***Interactive comment on “Brief communication:
Remotely piloted aircraft systems for rapid
emergency response: road exposure to rockfall in
Villanova di Accumoli (Central Italy)” by
Michele Santangelo et al.***

This document contains a point-to-point answer to the comments of reviewer #1. Reviewer comments (RC) are reported. Responses (AR) follow each RC. Quotations from the manuscript are in italics between inverted commas.

ANSWERS TO REVIEWER 1

Fig. 1.

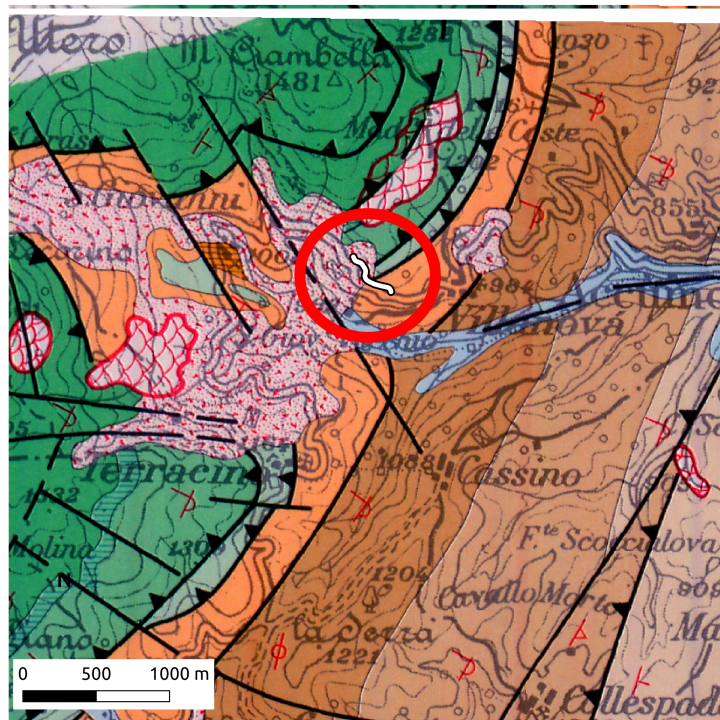
RC: A geological map, that would have been useful, is also missing.

AR: The scale of the available published geological map is 1:100,000, which is quite disproportionate compared to the extent of the study area. That is why we did not add a geological map since it was not really useful to the understanding of the paper. We still maintain this idea. Given its scale, the readability of the area would require to add a figure to the paper, going beyond the requirements of a brief communication, and not really improving the readability of the paper.

Attached is a figure (Figure 1) that contains an excerpt of the available geological map. The red circle locates the study area, whereas the white polygons is the portion of the road that was studied.
